APPENDIX I
RESPONSE TO USFS, ADEC AND EPA COMMENTS
ON DRAFT SITE CHARACTERIZATION REPORT

Document ID:	Revision ID:	Document Title: Draft Site Characterization Report Ross-Adam Mine Site, Tongass National Forest, Prince of Wales Island, Alaska

Figure 2
Ross-Adams Mine Site
Draft SCR: July 16, 2010 Response To Comments

Precipitation @ Annette Island, AK

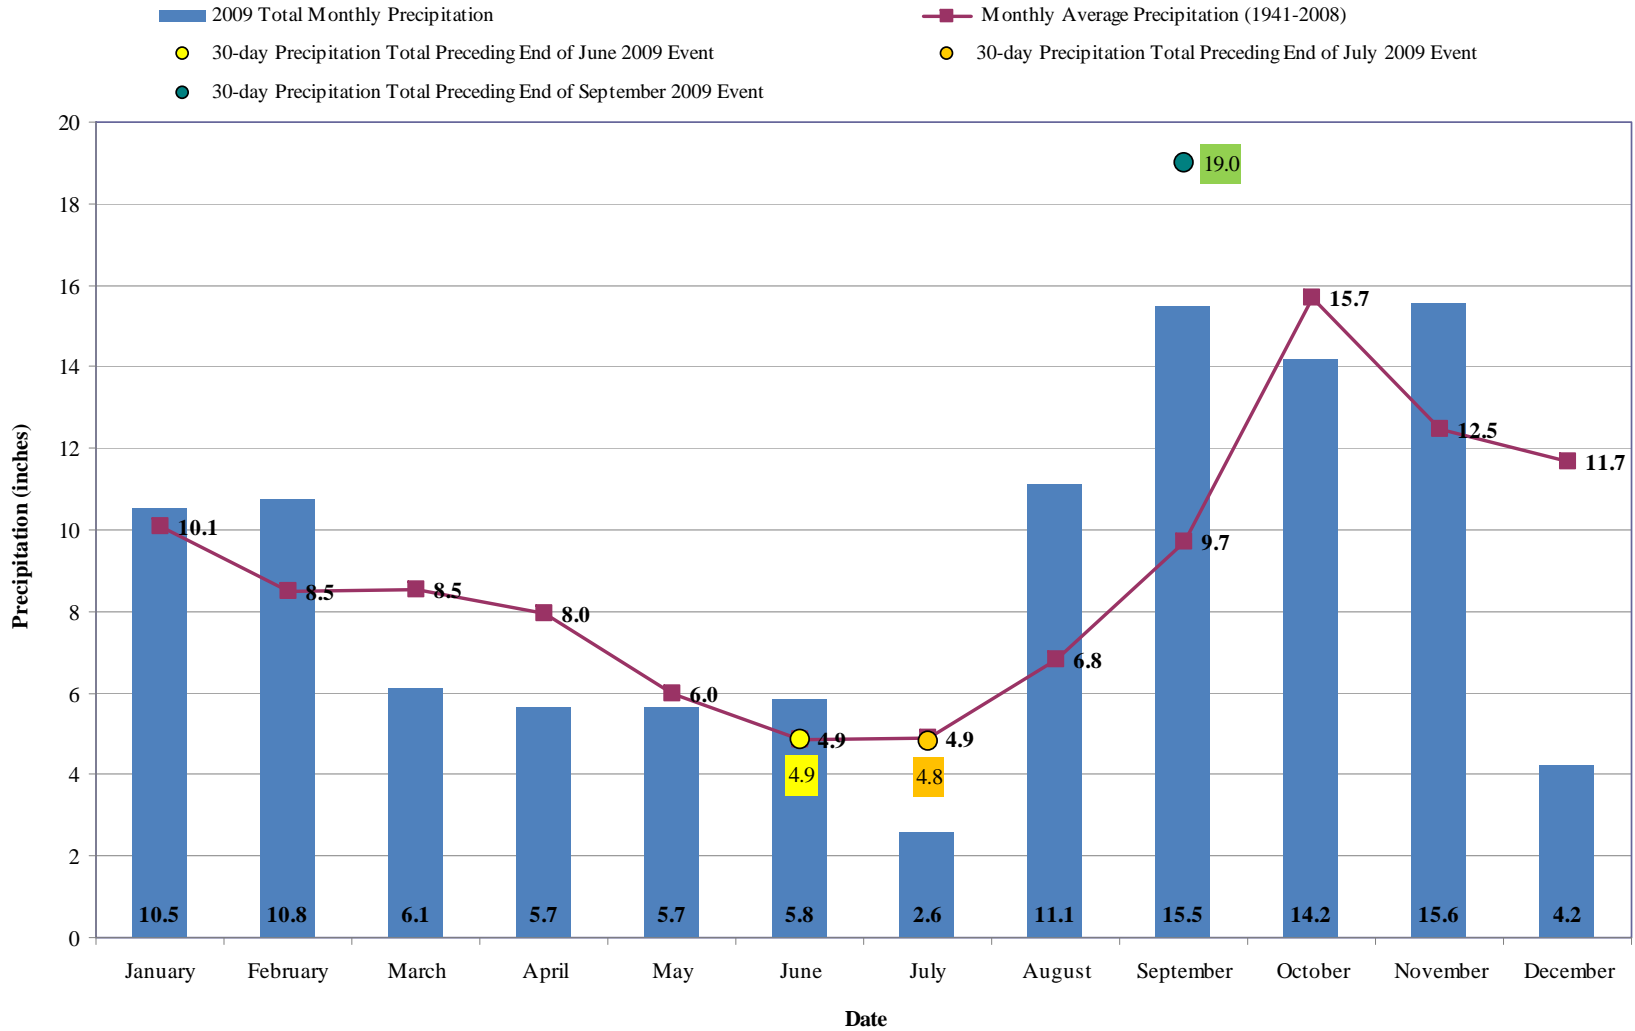
20	Section 6.2.4, page 144		No local new local background sample was collected near the 700 Level Creek	The SOW and SAP did not provide for collection of a surface water background sample for the 700-Foot Level Creek. Furthermore, the primary sources of water for the 700-Foot Level Creek are surface runoff from mine-affected areas of the 700-Foot and 900-Foot levels and any drainage from the 700-Foot Level portal. Because of these conditions, an un-impacted background water quality sample could not be collected for this creek. The nearest background surface water sample was collected on Kendrick Creek between the 700-foot and 800-foot contours (700L-SW-01-A).	
21	Section 6.3		Surface water samples were collected during a dry period with low stream flows. Effect of precipitation runoff and	The three surface water sampling events performed for the ESI provide data to characterize surface water flow and

Item No.	Location (page, par., sen.)	COMMENTS	Contractor Response
			<p>Precipitation records from Annette Island, the nearest meteorological station to the Site, indicate that precipitation (attached Figure 1) immediately preceding the September sampling event was significantly greater than the historical average and representative of precipitation during the wet season, resulting in stream flows representative of high flow conditions during the wet season. Stream flow records for Old Tom Creek near Kasaan (USGS station 15085100), the nearest USGS stream gauging station to the Site show that daily mean discharge data for Old Tom Creek (attached Figure 2) during late September 2009 were representative of stream flows during the wet season. The higher stream flows measured at the Site coupled with the Annette Island precipitation and USGS stream gauging records demonstrate that the September sampling event was representative of higher stream flow conditions at the Site during the wet season.</p> <p>Comparison of water quality data collected during the three sampling events at the Site allows the effects of higher precipitation and higher stream flows on water quality to be evaluated. Water quality generally improves with increased stream flow. Concentrations of key constituents sampled at stations in Kendrick Creek downstream of mine features decrease or are similar during the higher stream flows in September compared to the June and July sampling events. As shown on Figures 6-34 and 6-35 of the SCR, uranium, zinc, and radium concentrations in Kendrick Creek downstream of the 300-Foot Level mine rock pile at 300L-SW-01-A decrease during the higher stream flows in September compared to the lower stream flows in either the June and July sampling events. Uranium and radium concentrations of the drainage from the 300-Foot Level portal also decreased due to the significantly higher flow observed from the 300-Foot Level portal in response to the precipitation in September.</p>
